ADDENDUM #2

Issued: November 21, 2025

The following changes/clarifications are effective immediately and shall be incorporated into the Contract Documents:

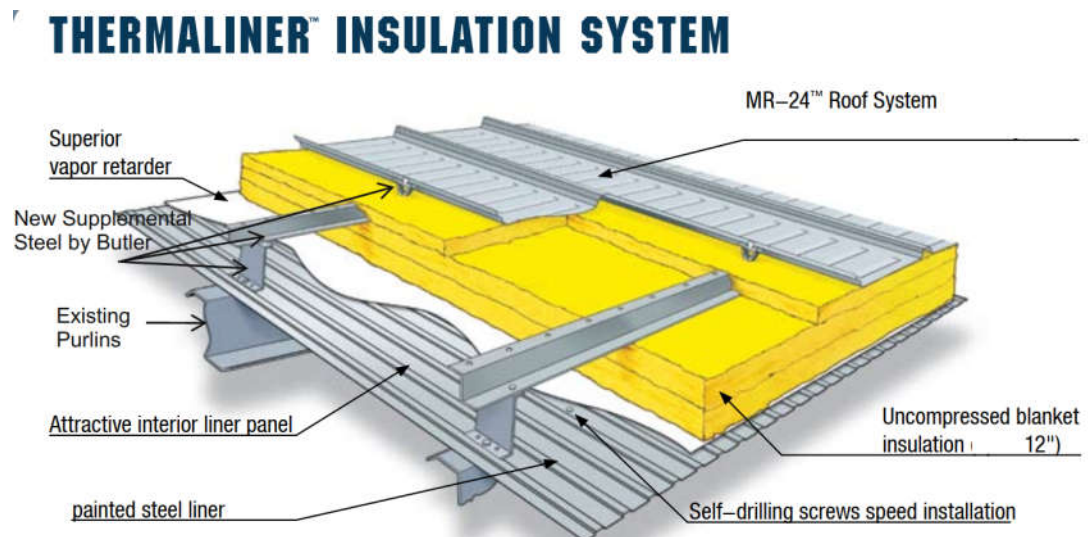
Question: 9: Blanket insulation. The plans and spec both make reference to a blanket insulation, but in the spec the only two products listed are Rockwool AFB and Multifix by Rockwool, neither of which is a blanket insulation. Can you please confirm what product you are looking for to be used in the wall cavities?

Answer: Delete reference to Rockwool AFB and Multifix by Rockwool. All walls shall have a blanket insulation 8” (approx. R25) and roofs a 12” (approx. R40) uncompressed blanket insulation supplied through the roof/wall panel supplier (Butler Mfg or approved equivalent system). Reference the specified Butler Mfg TLS-12 roof system – see image below.

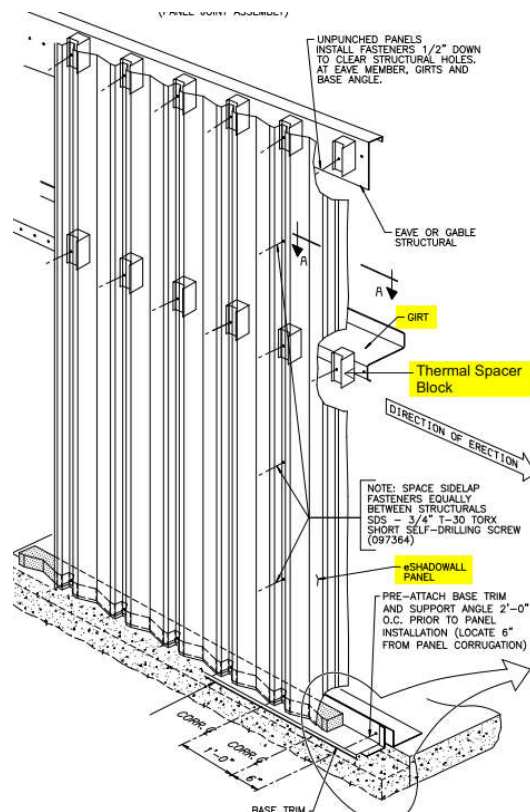
Question: 10: The wall compositions on the drawings call for Thermal spacers, some parts of the spec talk about Iso clips. Is that what they mean by thermal spacers?

Answer: Delete reference to ISO-clips. Reference the specified eShadowall details. The thermal spacer blocks (approx. 2" deep) are installed on the exterior face of the girts at every siding corrugation connection with the panel attachment fastener centered and penetrating through each thermal spacer block. See image below.
